Access Compliance Report

Public Rights-of-Way

(Curb Ramps)

Intersection ID: 14741	Main Street: EAST_BV	Cross Street: PARK_RD	Location: SW
ADA ID: D66ACBD825EC	Ramp Type: Directional1	Initial Pass/Fail: Fail	Overall Compliance: No
Severity Score: 13.75			
Codes/Mitigation Info/Possible Solution		Field Measurements/Component Compliance

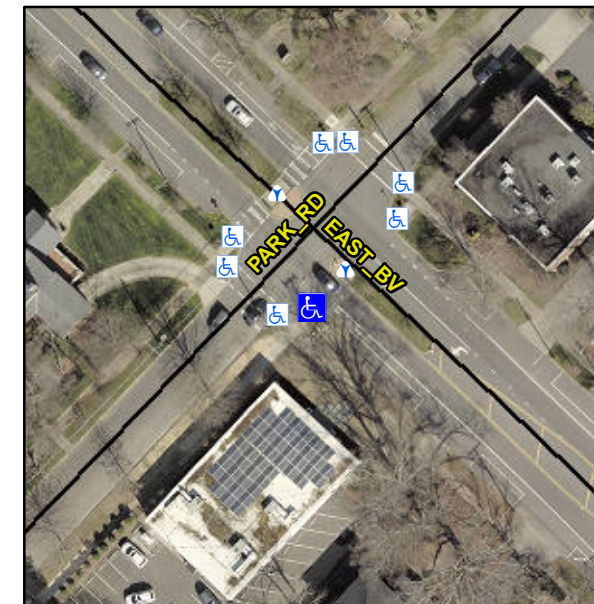
Possible Solutions:

Remove & Replace Entire Ramp.

PROW/ADA:

R304.2.2, R304.5.3
